Halton District School Board

Addendum No. 4

RFT 26-030 Oakville #5 Elementary School & Child Care Facility

ADDENDUM NO. 4**Issued February 10, 2026**

QUIET ROOM CURTAIN WALLS - 231, 229, 331, 329

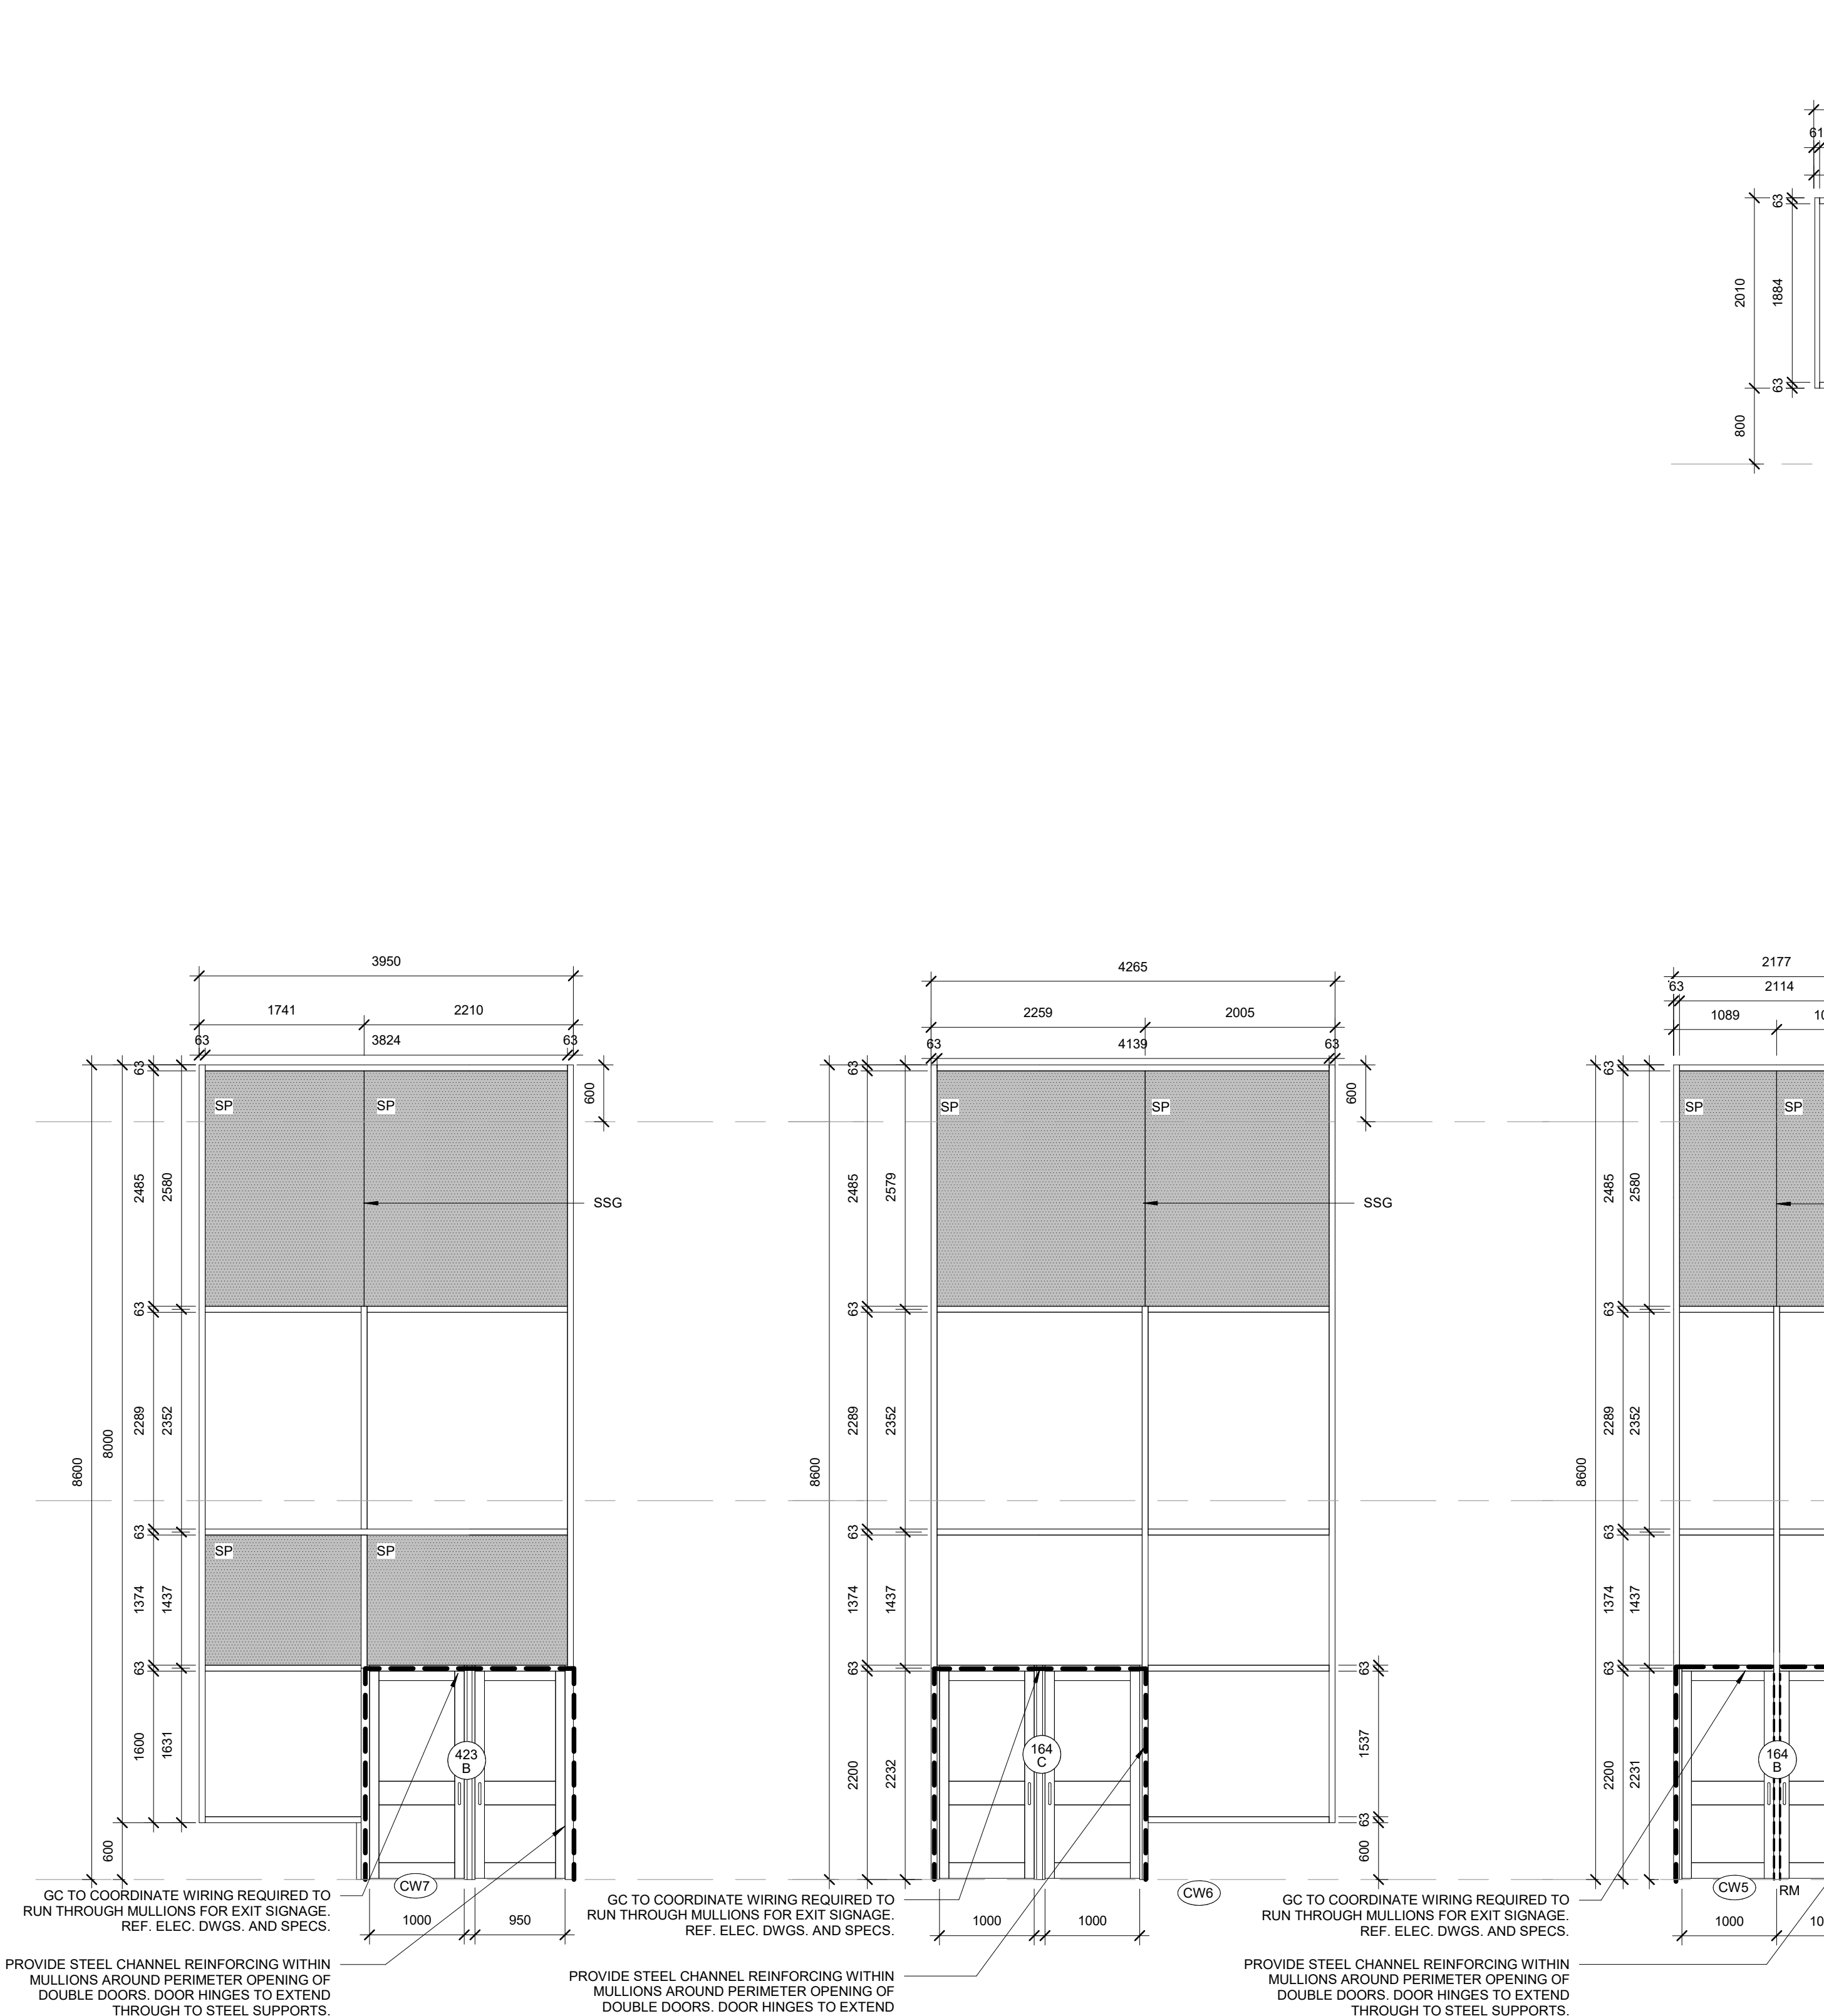
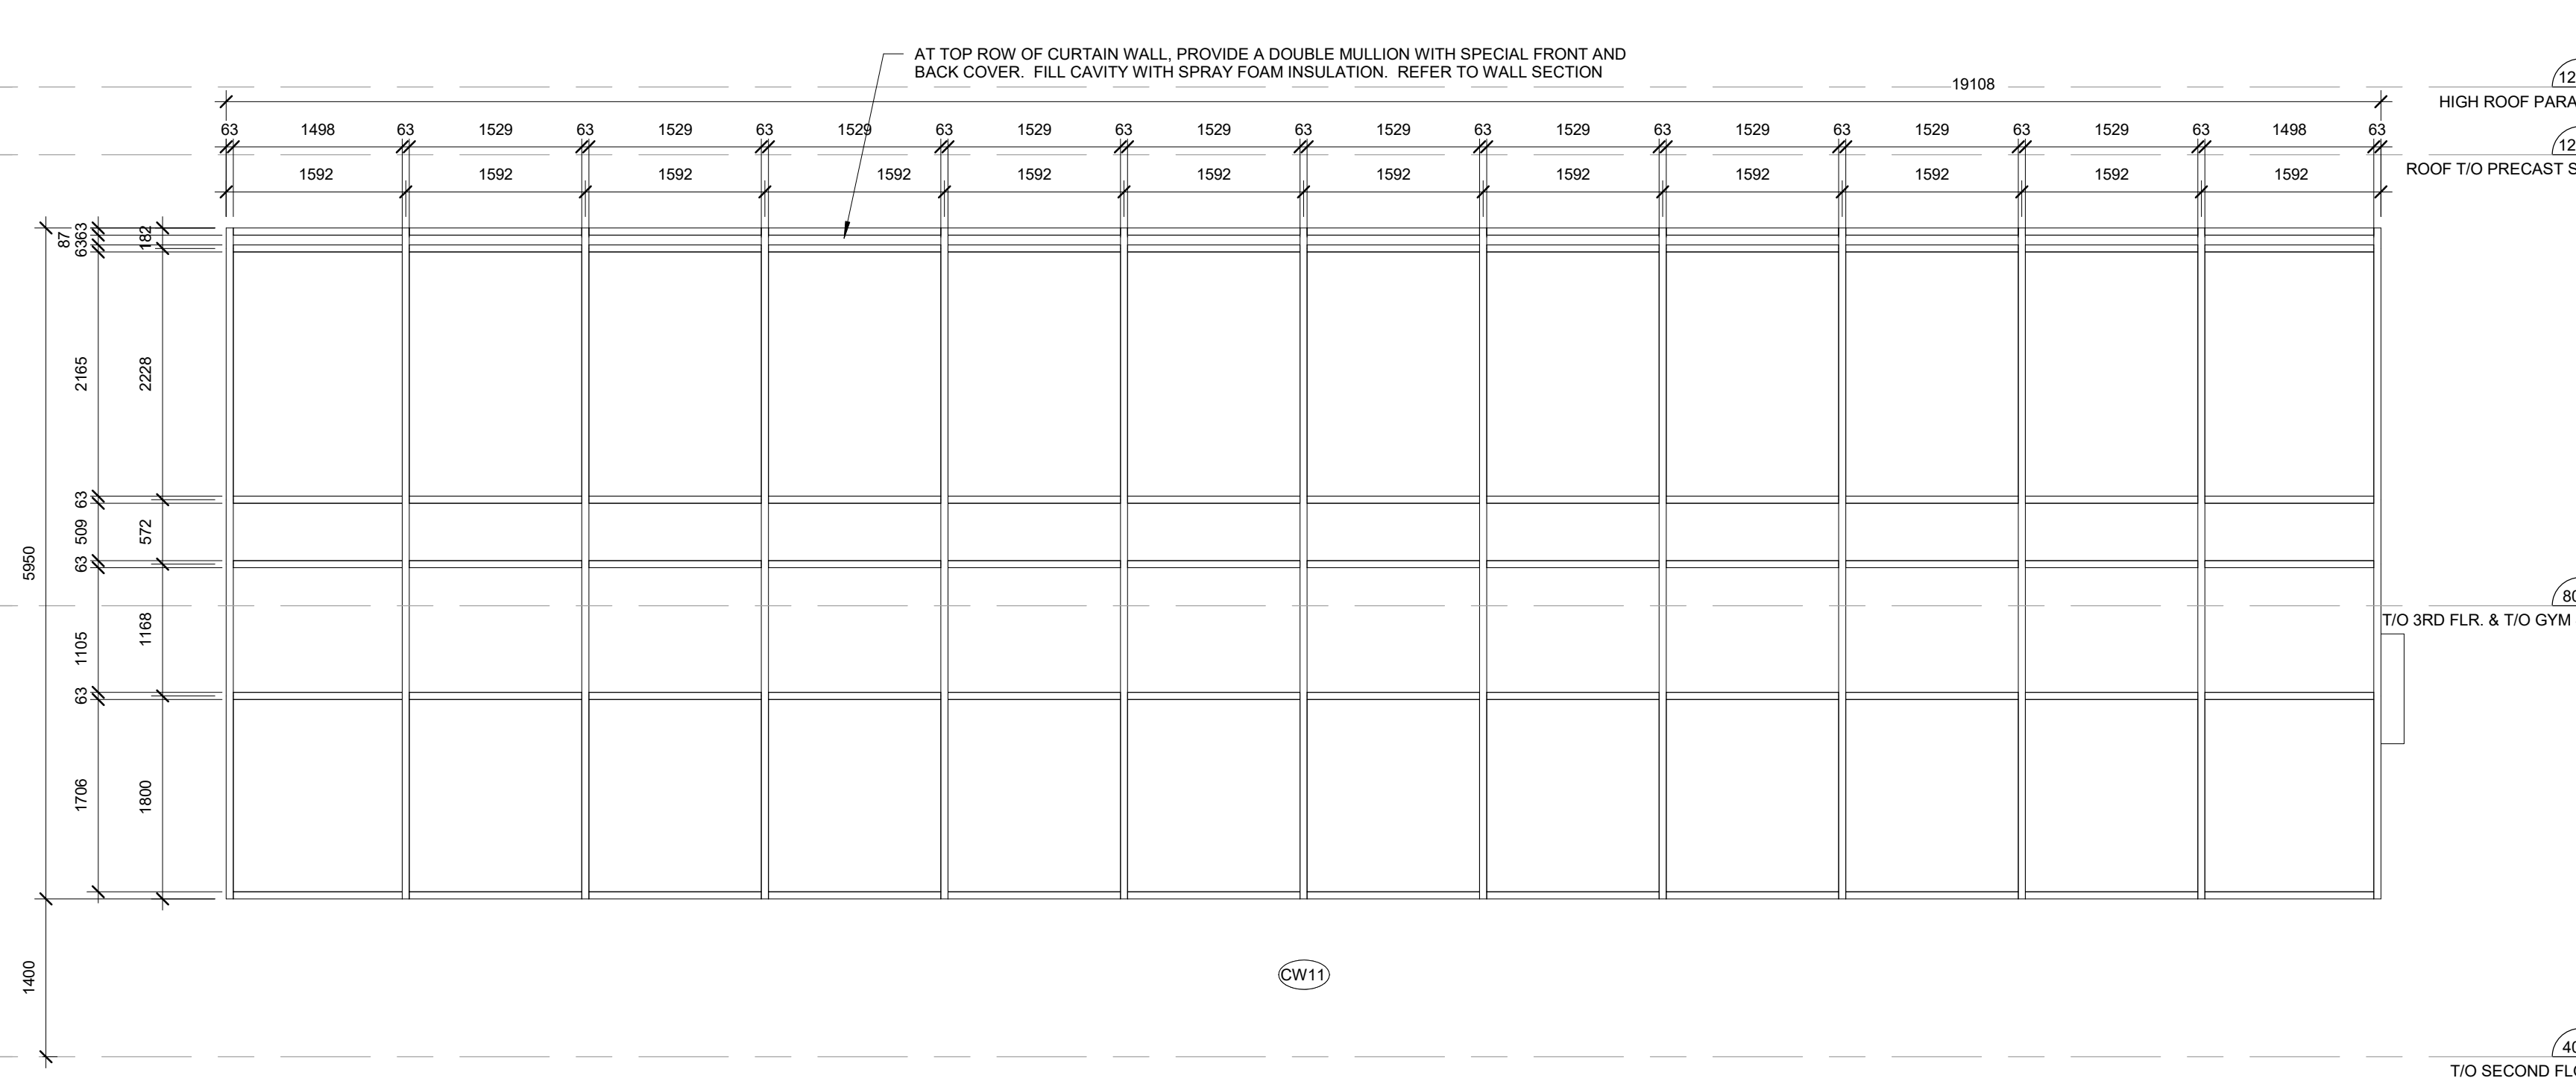
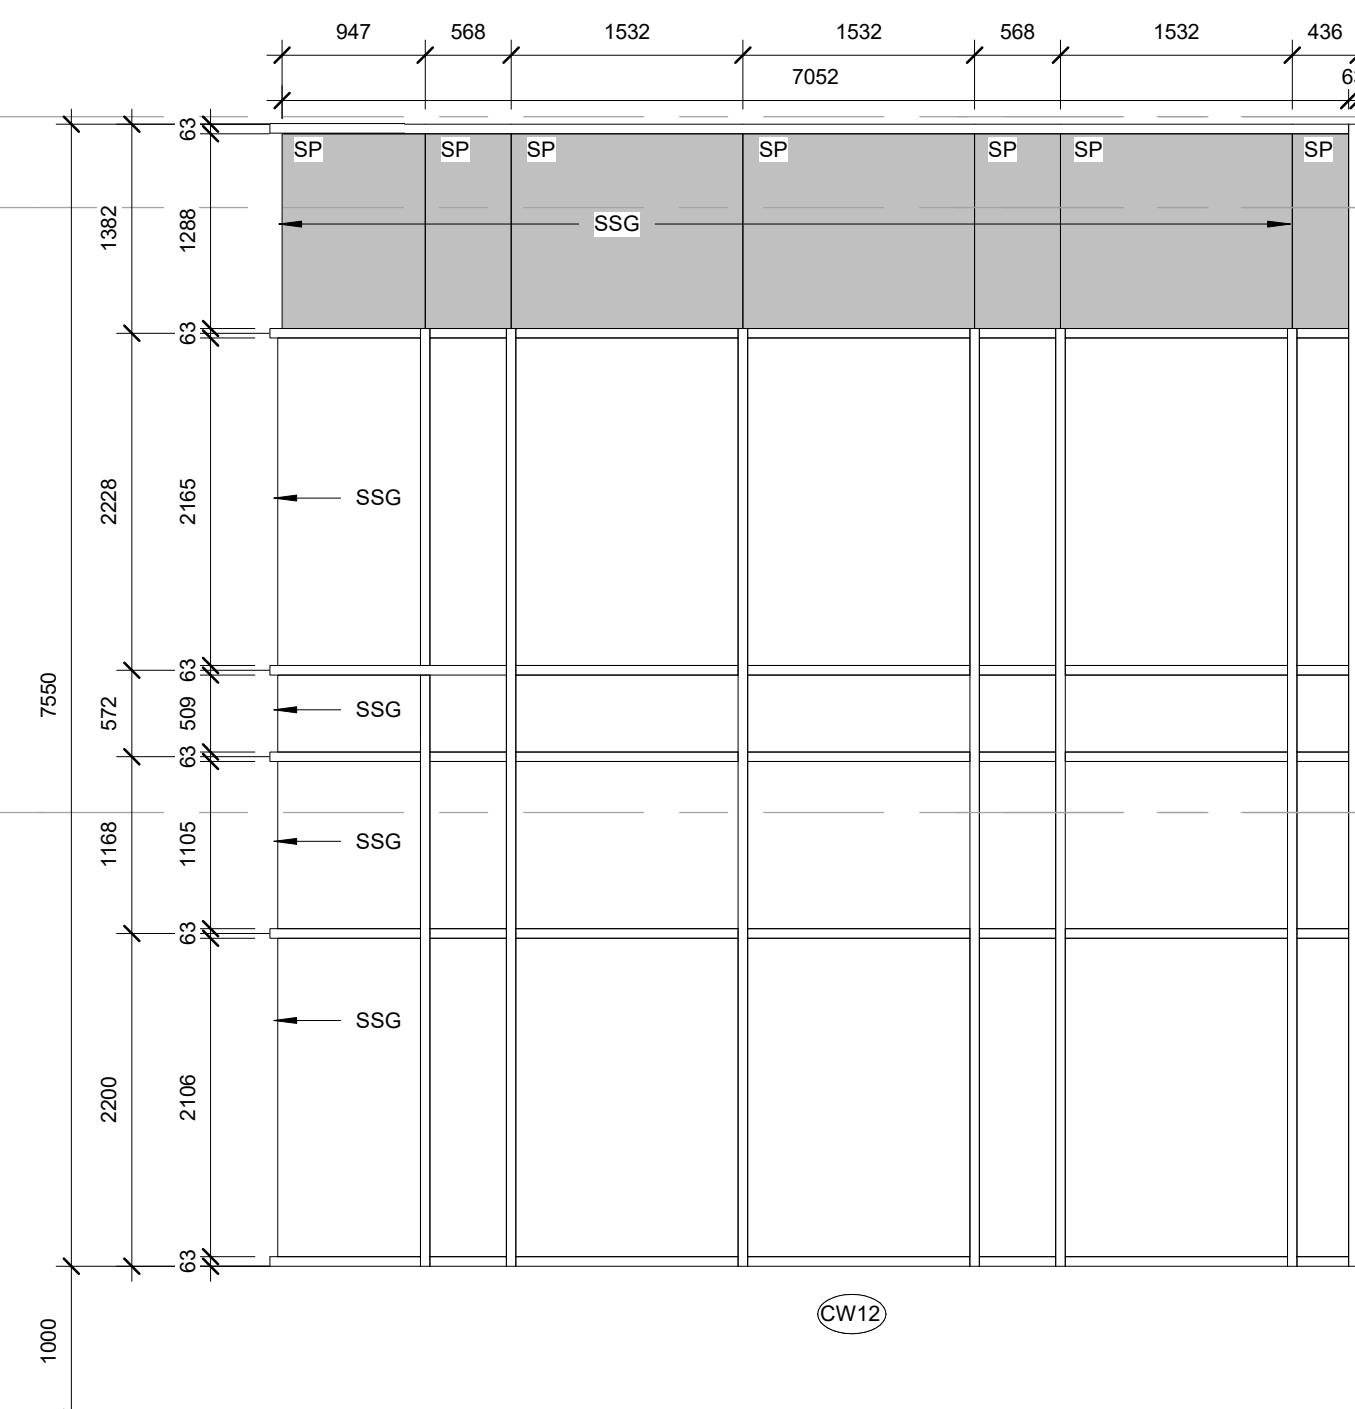
- .1 REVISE: QUIET ROOM 229, 231, 240, 245, 248, 329 and 331 wall finish to read: "BB / POR.WD".
- .2 REVISE: 'QUIET ROOM 229, 231, 240, 245, 248, 329 and 331 remarks to read: "REFER TO CURTAIN WALL SCHEDULE. BB ON ENTIRE WALL REFER TO ARCH. PLANS."
- .3 DELETE references to 'smoke baffles' in '157 Stair A' and '201 Stair A'.
